# PLANNING BOARD MEETING

RE: Nitsch Project #11123.8  
Perry Estates  
Site Plan Review  
Randolph, MA

Nitsch Engineering reviewed the revised plan set for the proposed Perry Estates subdivision located at 297 Chestnut Street in Randolph, Massachusetts (the Town).

25 FT RIGHT OF WAY LAYOUT  
NOT TO SCALE

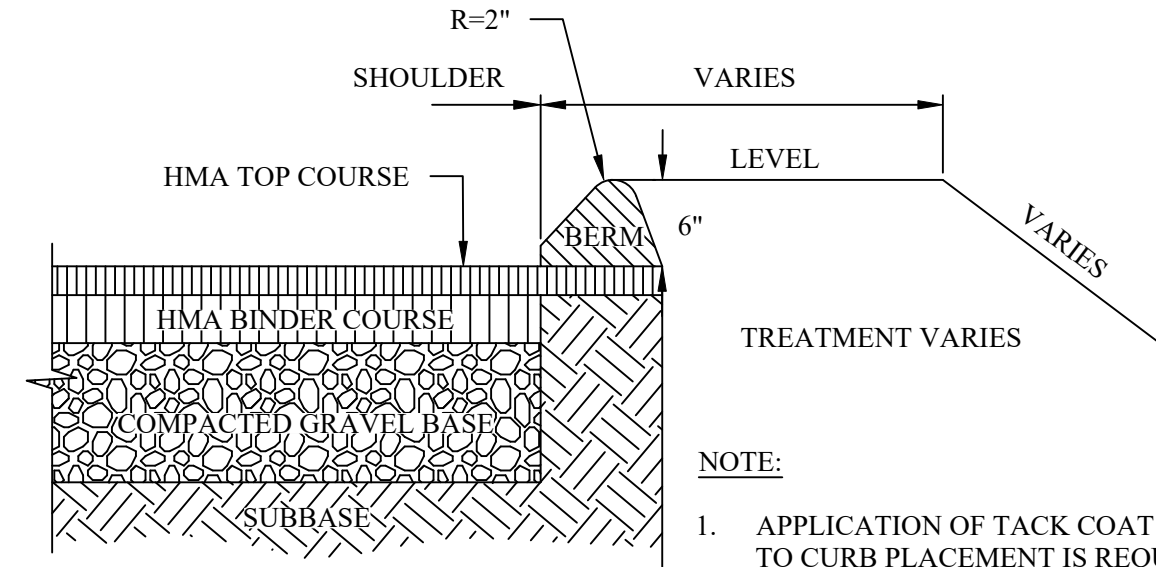
1. Section VIII.B4e states that all corners of street intersections shall be rounded or cut back to provide for a minimum radius.
2. Section VIII.B5 states that ways shall be laid out to widths of forty feet (40') or fifty feet (50') based on type. Ways of greater width may be required by the Board where traffic or other considerations warrant.
